# CITY OF ALBUQUERQUE

October 30, 2024

After a thorough review of your minor amendment application for the Eastdale Shopping Center, located at 9450 Candelaria Road NE, we have the following comments that must be addressed prior to approval. If any portion of the proposed amendment can stand on its own, we may proceed with approving just those portions and may delay other site plan changes to the future, if desired.

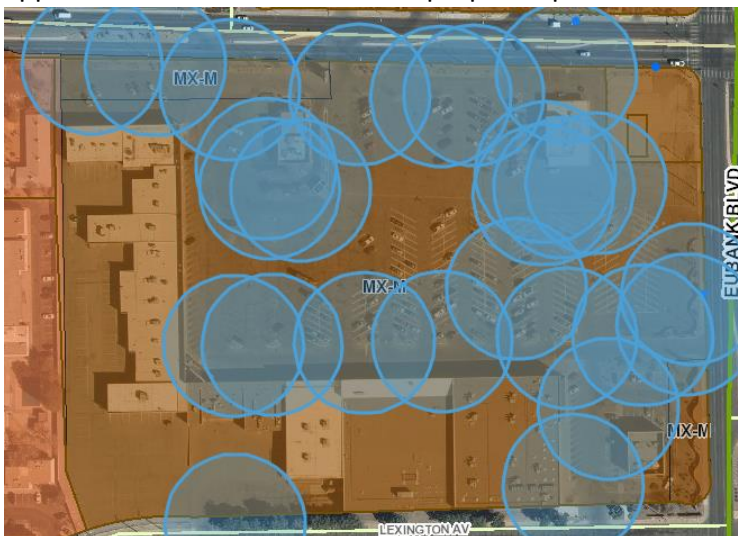
19. 1 tree is required per 10 parking spaces. No parking space may be more than 100 feet from a tree trunk. The proposed removal of islands and trees from the center of the parking lot creates a deficiency with this code requirement. Other areas that are already deficient may need to come into compliance. See graphic below showing potentially deficient areas based on approximate tree locations in the proposed plan.
